DRAFT PLANS
for pricing only
CCO 36 Sheet 1 of 6
Date 5/23/07

SAN FRANCISCO OAKLAND BAY BRIDGE
EAST SPAN SEISMIC SAFETY PROJECT
SELF-ANCHORED SUSPENSION BRIDGE
(SUPERSTRUCTURE & TOWER)

TOWER ANCHORAGE DETAILS NO. 2

DETAIL A
TOWER BASE PLATE LAYOUT
1:20
(Tower base stiffeners are not shown for clarity)

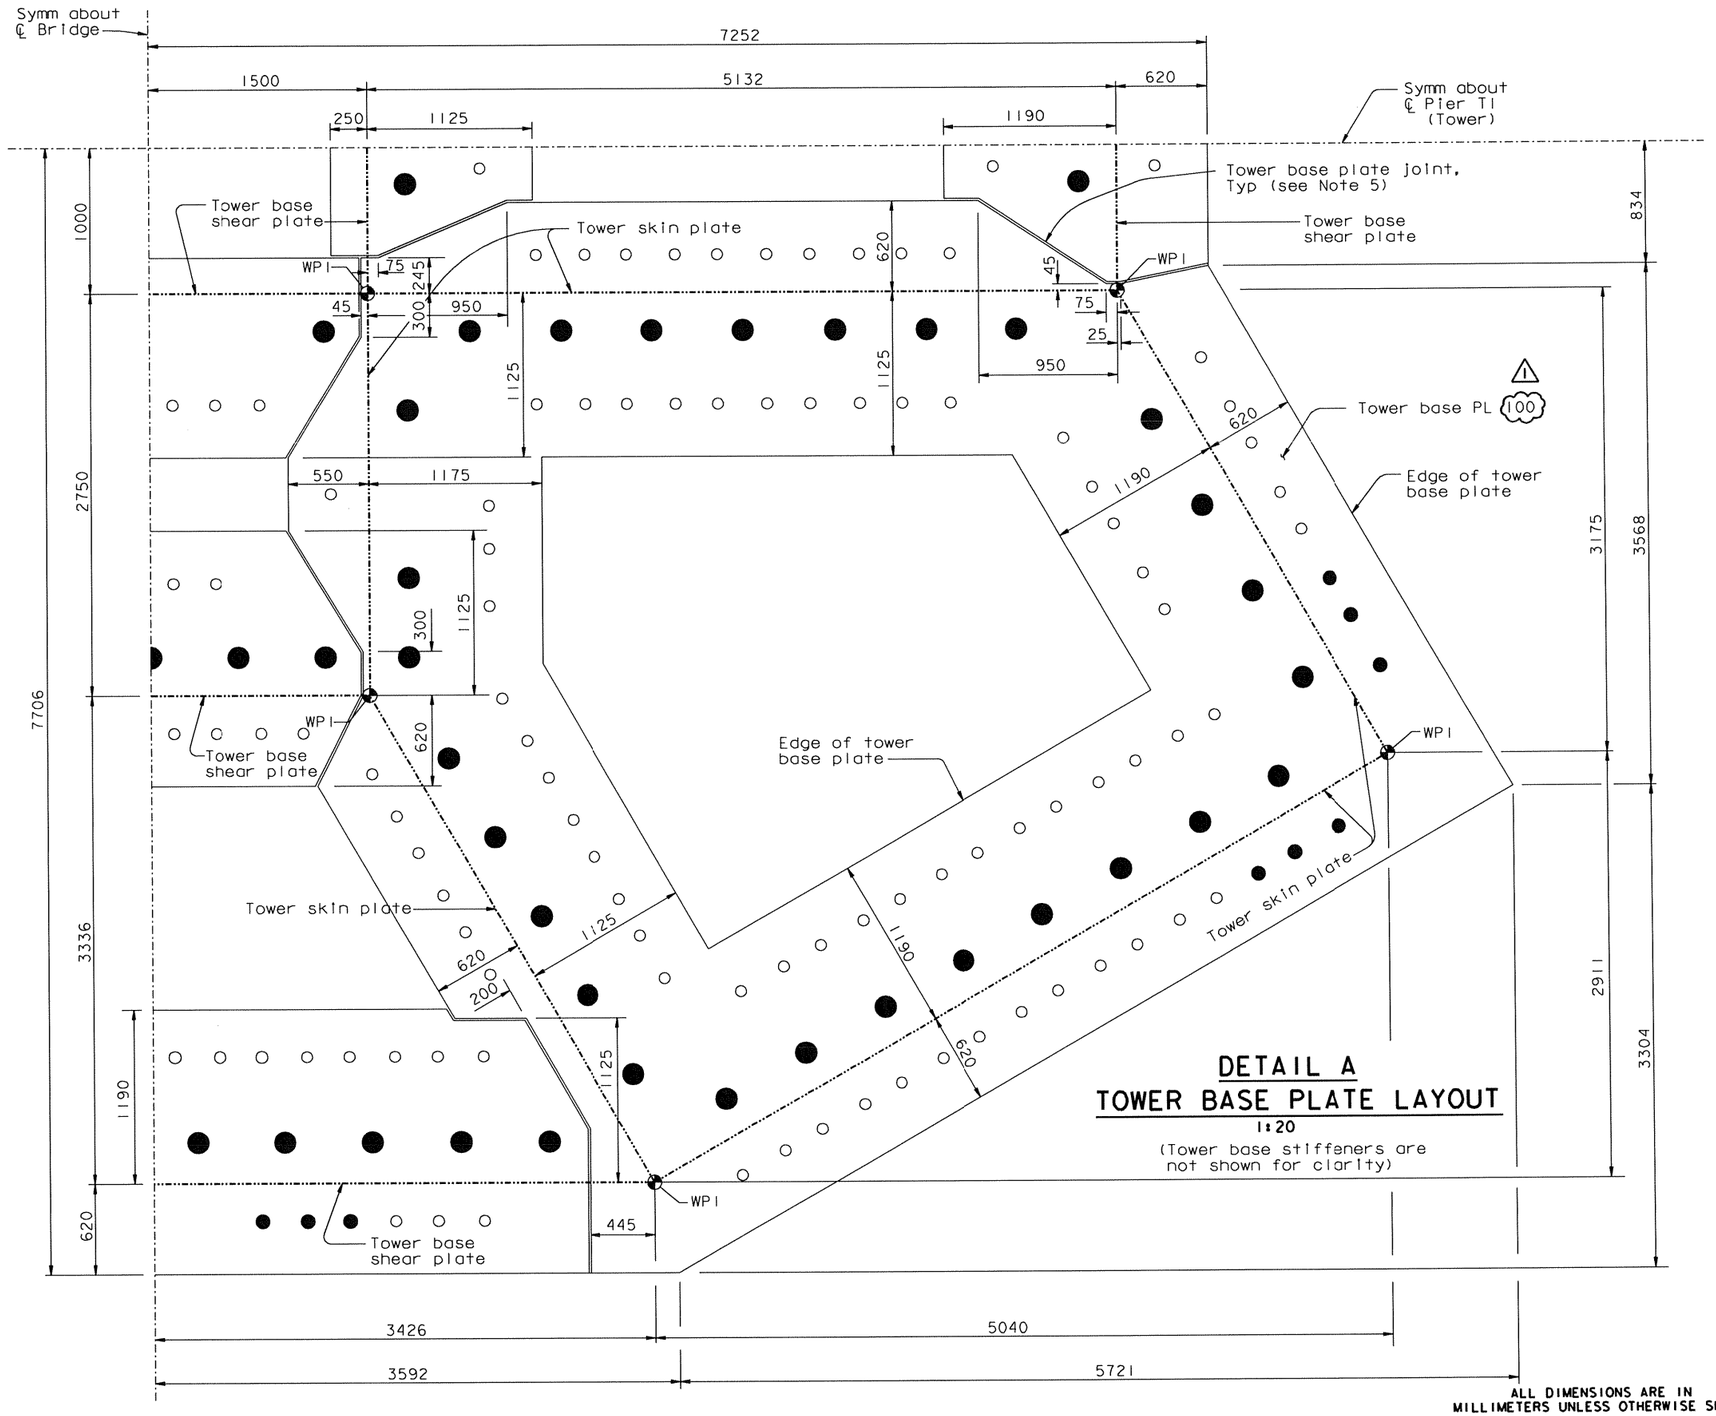
MARK	DATE	DESCRIPTIONS	BY	CH'D	CCO#
1	02/28/07	TOWER BASE PLATE	AS	MN	36

TOWER ANCHORAGE DETAILS NO. 4

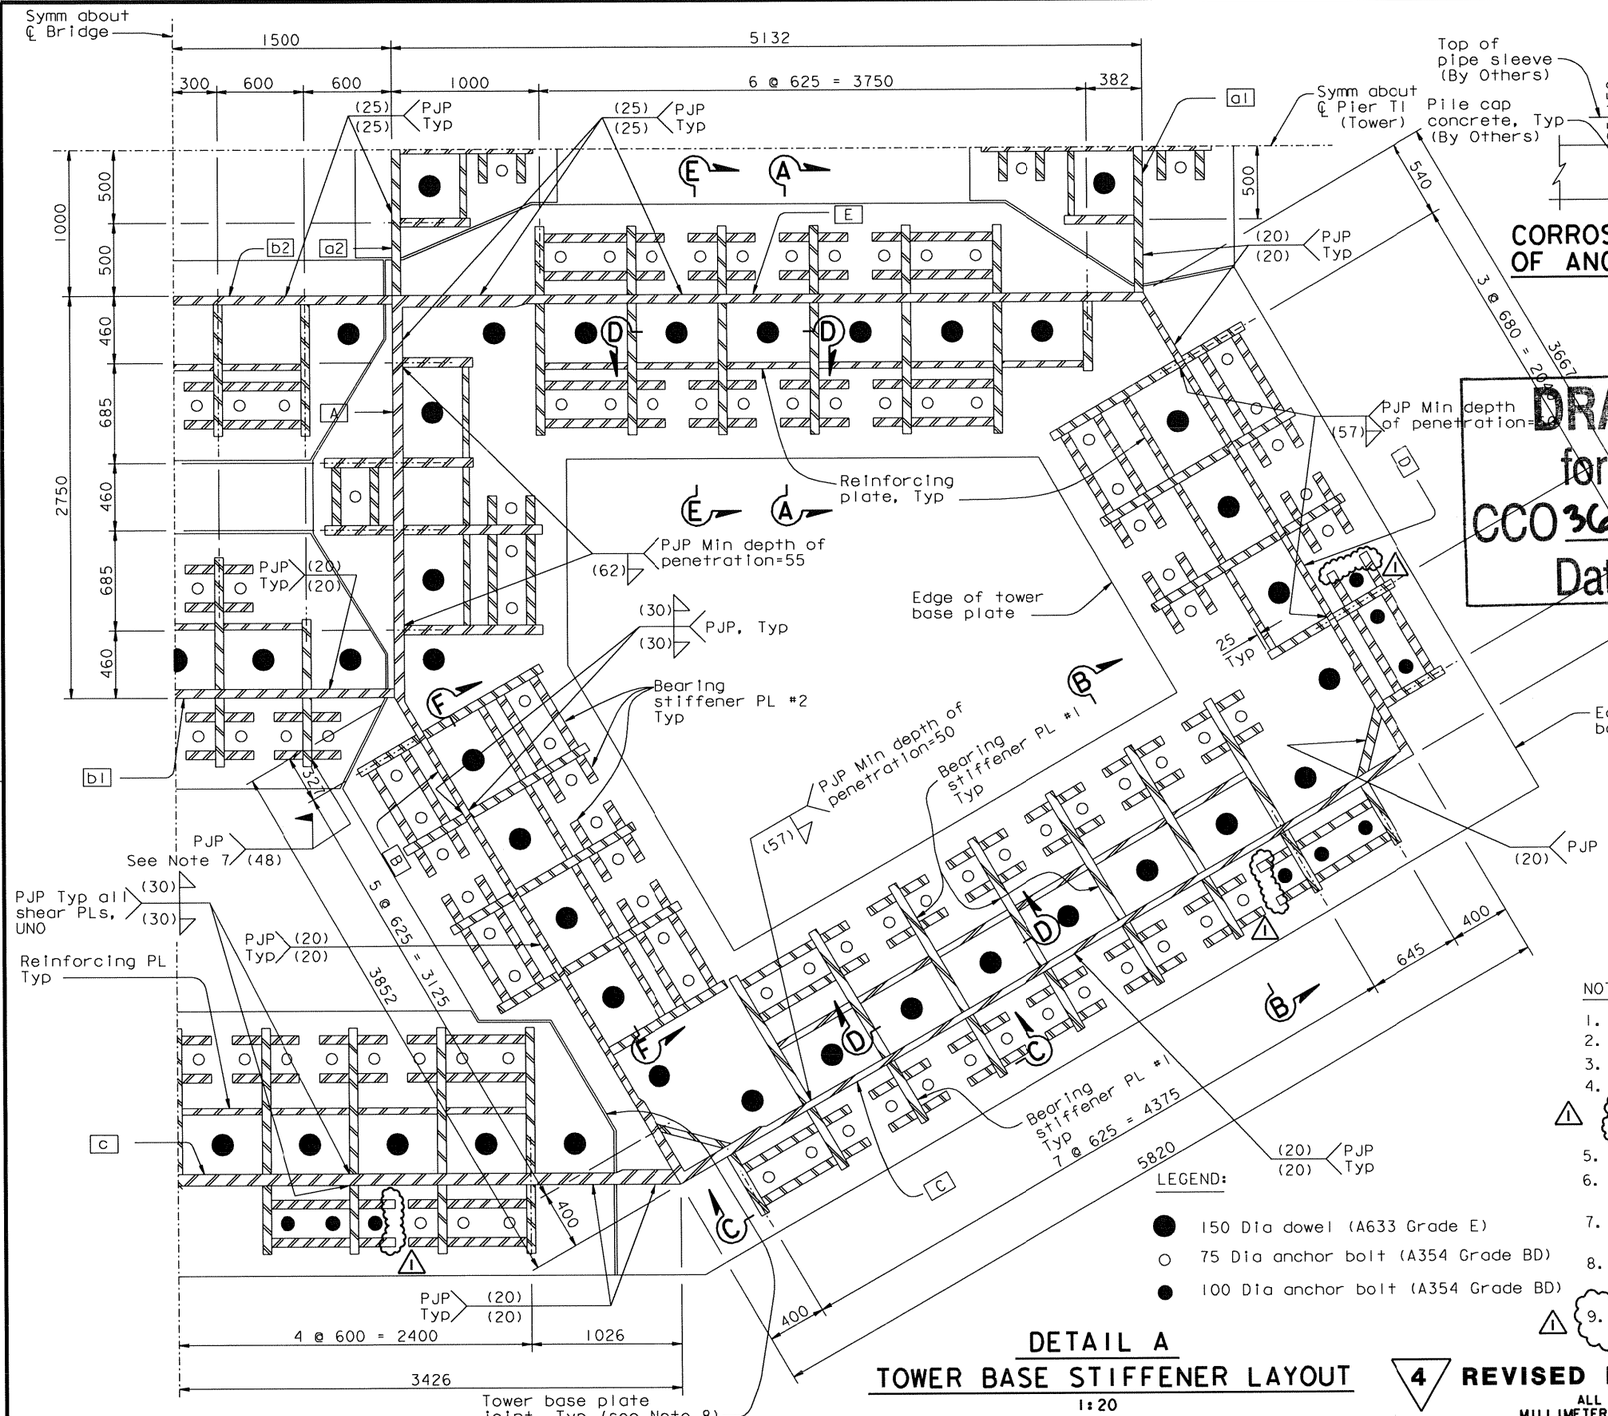
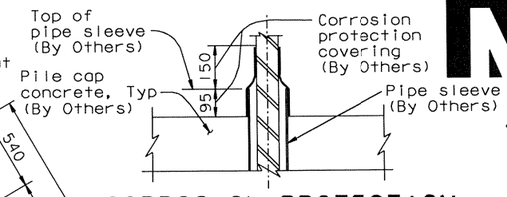
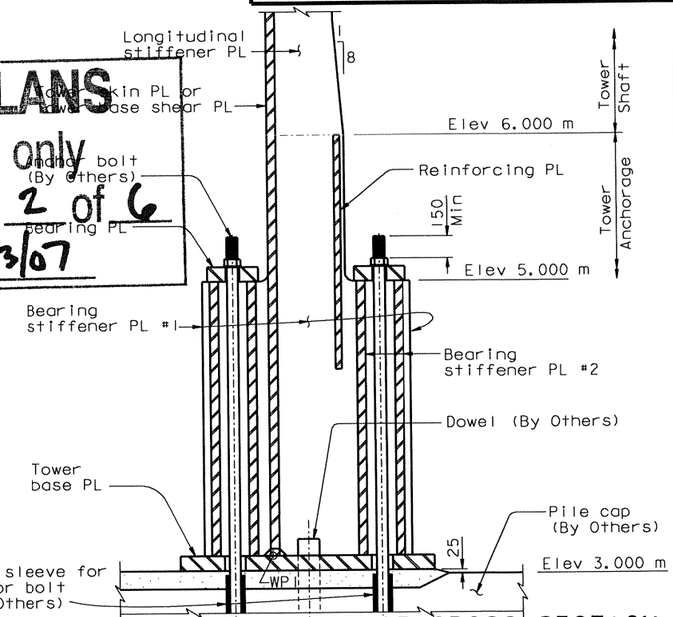
MARK	DATE	DESCRIPTIONS	BY	CH'D	CCO#
1	05/11/07	TOWER STIFFENERS	MN	NV	36

- -1800 kN for 75 diameter anchor bolts
   - -2530 kN for 100 diameter anchor bolts
5. For Section F-F, see "Tower Anchorage Details No. 7" sheet.
6. Contractor shall remove corrosion protection covering prior to grouting operations.

7. Field welding is for this bearing stiffener only. For welding of typical bearing stiffeners, see "Tower Anchorage Details No. 5" sheet.
8. For details of tower base plate joint, see "Tower Anchorage Details No. 8" sheet.

9. (1) At the Contractor's option, an equivalent 2-sided PJP may be used instead of a 1-sided PJP.

TOWER ANCHORAGE DETAILS NO.5

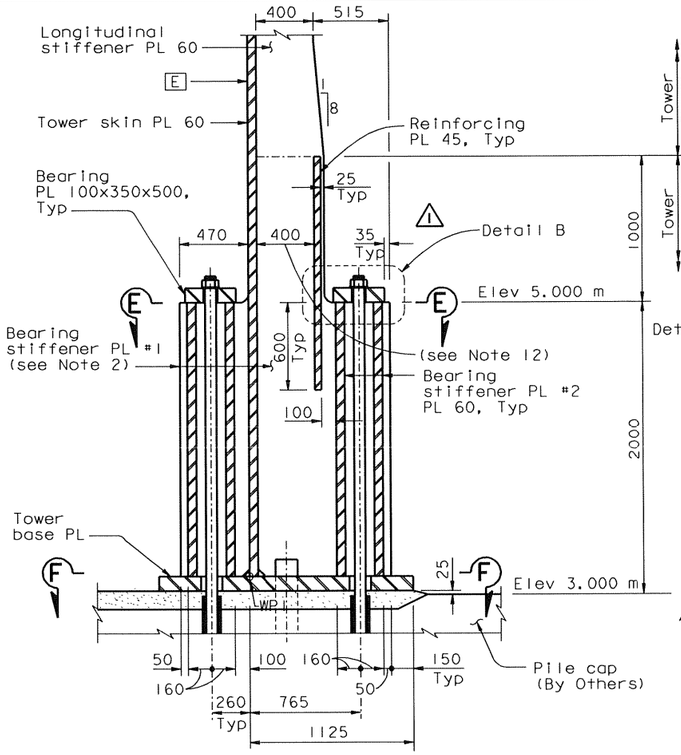
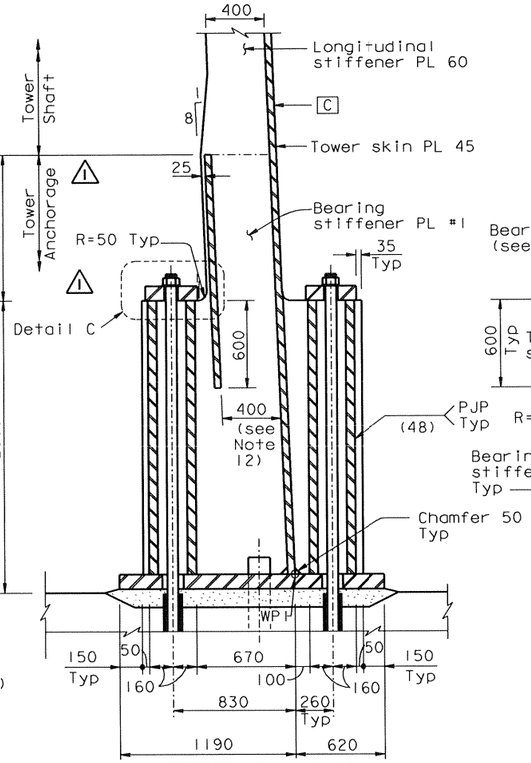
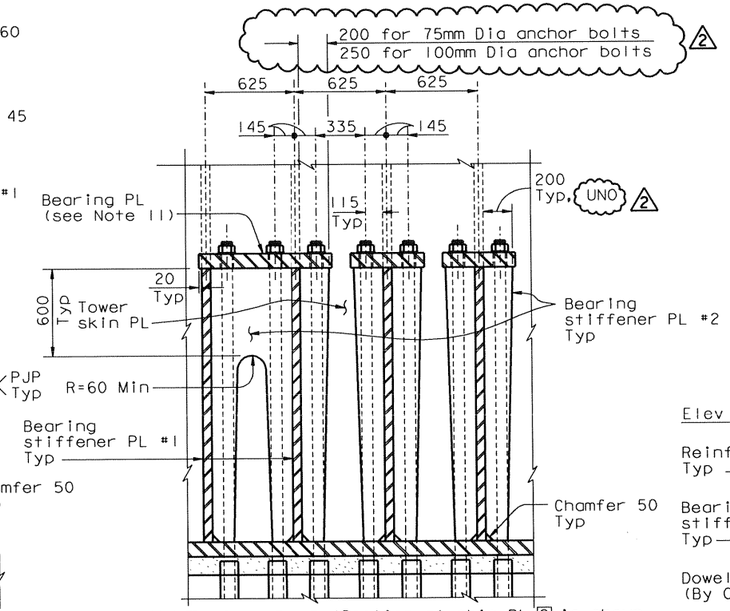
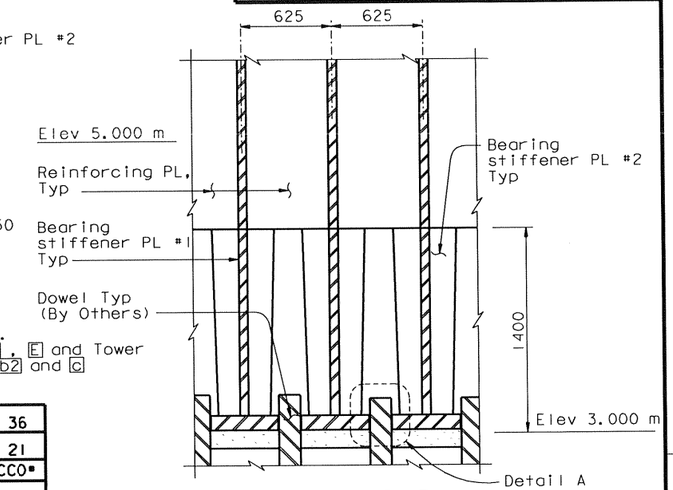
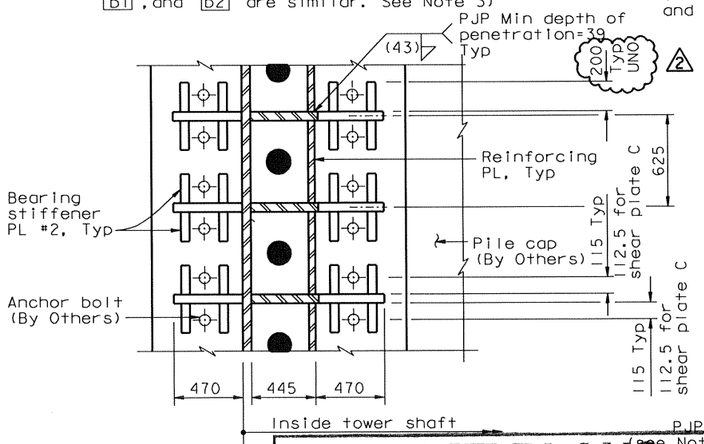
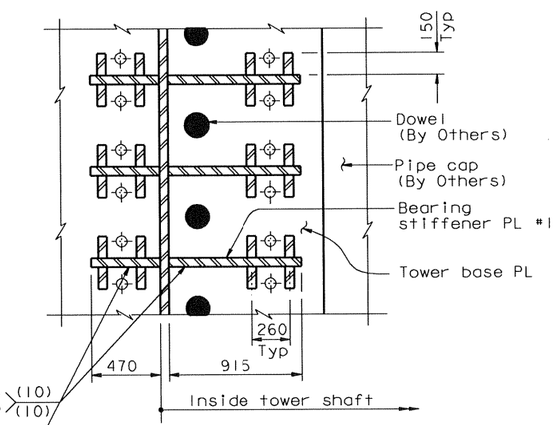
MARK	DATE	DESCRIPTIONS	BY	CH'D	CCO#
2	05/11/07	TOWER STIFFENERS	MN	NV	36
1	06/23/06	DELETE GAP TABLES	MN	NV	21

9. For Details B and C, see "Tower Anchorage Details No.6" sheet.
10. Bearing stiffener PL #2 shall be milled to bear against tower base plate.
11. A single bearing plate shall be used at locations where Bearing Stiffener PL #2 are connected.

12. The clear distance between the inner face of the tower skin plate and the reinforcing plate shall match the longitudinal stiffener plate width. For longitudinal stiffener plate width, see "Tower Shaft Details" sheets.

13. At the base of stiffeners two-sided PJP welds may be replaced with equivalent single-sided welds, subject to approval by the Engineer.

TOWER ANCHORAGE DETAILS NO. 6

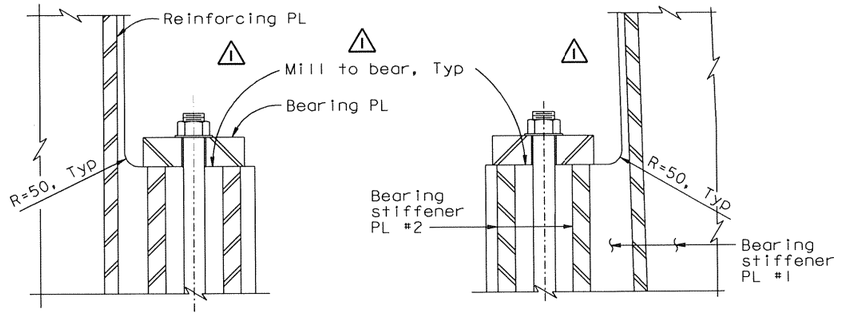
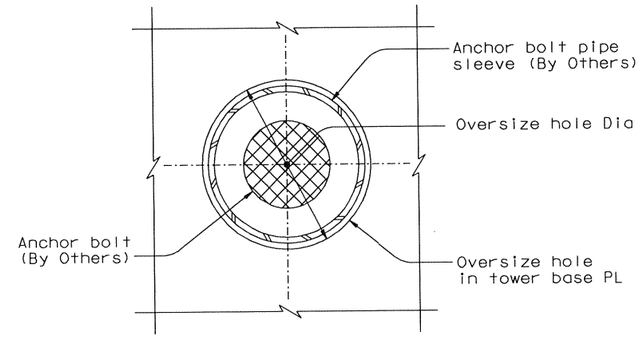
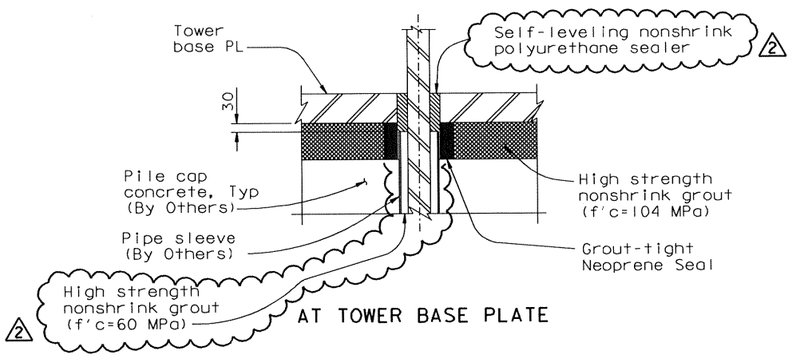
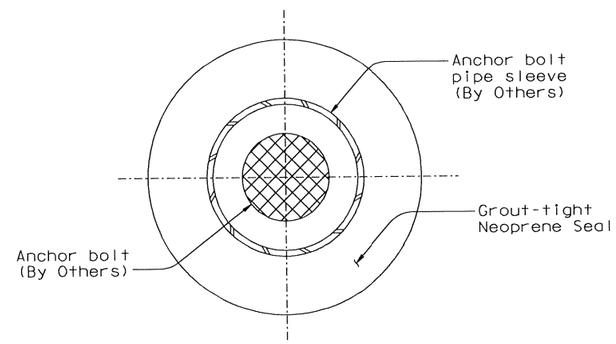
MARK	DATE	DESCRIPTIONS	BY	CH'D	CCO#
2	02/28/07	TOWER BASE PLATE	JD	MN	36
1	06/23/06	DELETE GAP TABLES	MN	NV	21

1. Anchor bolt pipe sleeve shall be filled with nonshrink grout. For additional prestressing details, see "Prestressing Notes" sheet.
2. The Contractor shall develop a scheme for grouting the anchor bolts and submit for review and approval by the Engineer.
3. Grout-tight neoprene seal shown is schematic and is for information only. The seal shall prevent any high strength nonshrink grout from seeping inside the anchor bolt pipe sleeves during grouting of the tower base plate. This is necessary for proper stressing of the anchor bolts. Once final stressing of the anchor bolts is complete, the pipe sleeves shall be grouted (see Note 2). The Contractor shall submit seal details consistent with his means and methods to the Engineer for review and approval.

TOWER ANCHORAGE DETAILS NO. 7

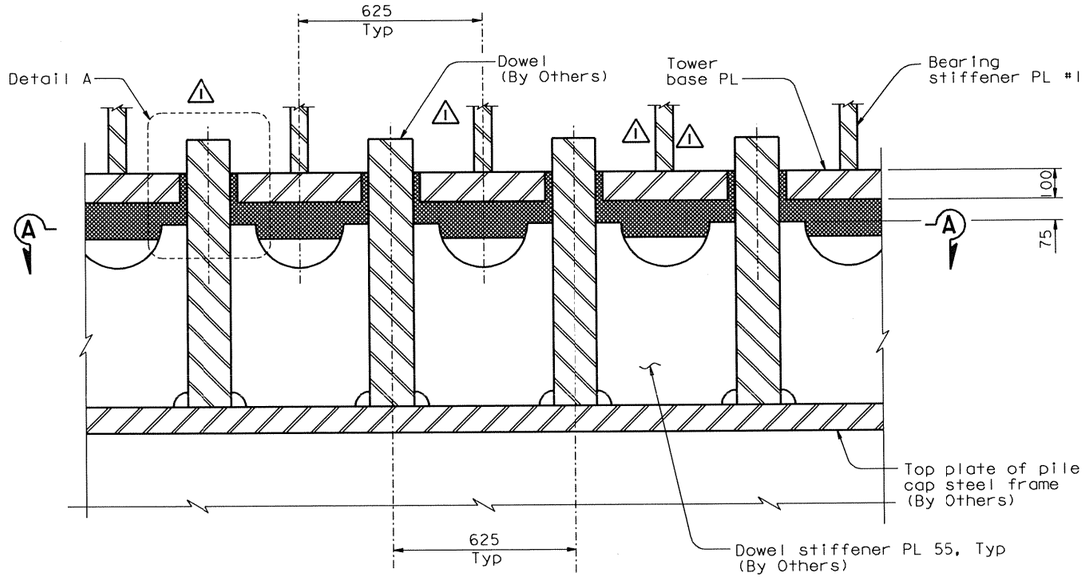
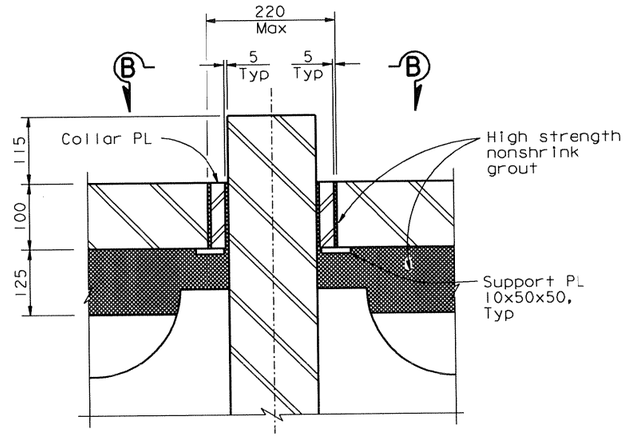
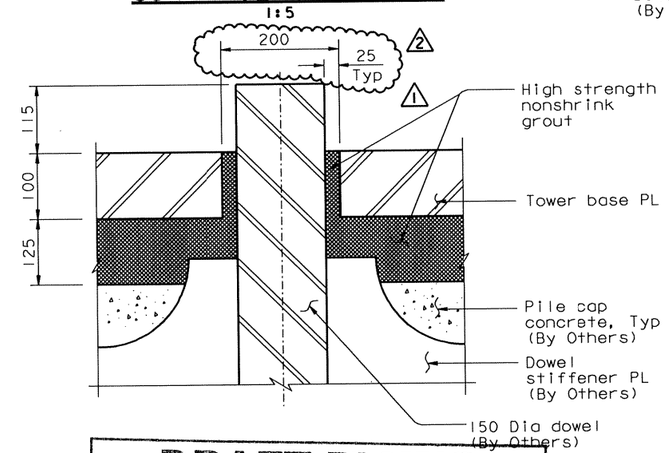
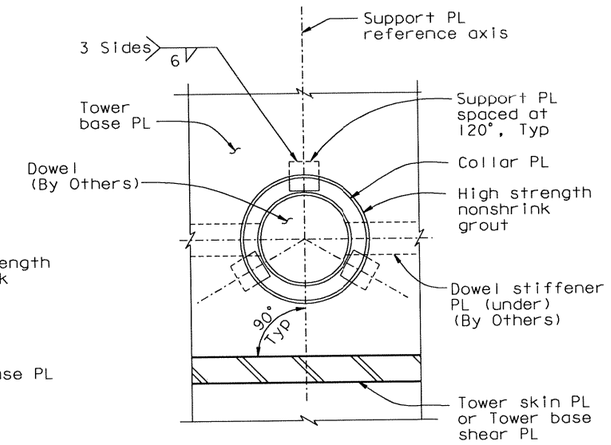
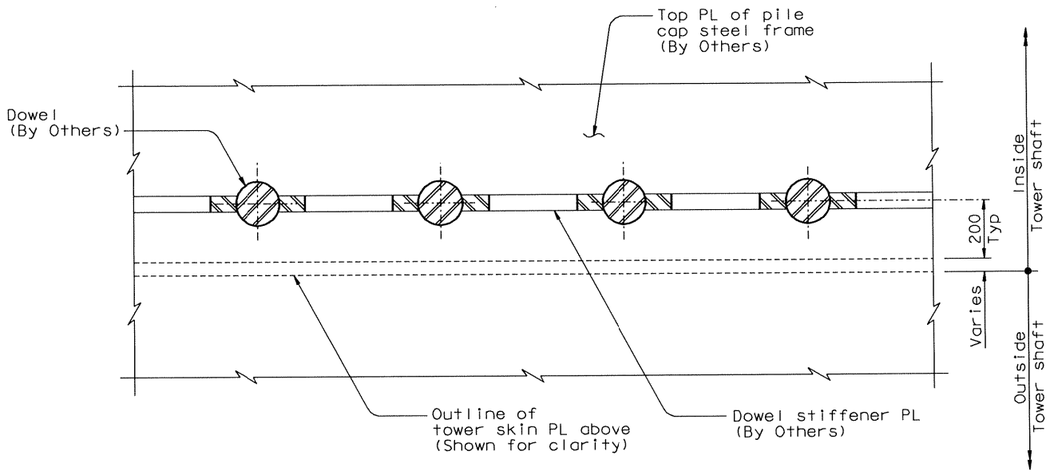
MARK	DATE	DESCRIPTIONS	BY	CH'D	CCO#
2	04/03/07	TOWER BASE PLATE	JD	MN	36
1	02/28/07	TOWER BASE PLATE	JD	MN	36

1. For dowel layout, see "Tower Anchorage Details No. 3" sheet.
2. Oversize hole in tower base PL is an acceptable alternative to accomodate tolerance requirements for the erection of the tower base plate. Collar plates shall be A709M Gr. 345 and shall be fabricated based on field measurements and then installed.
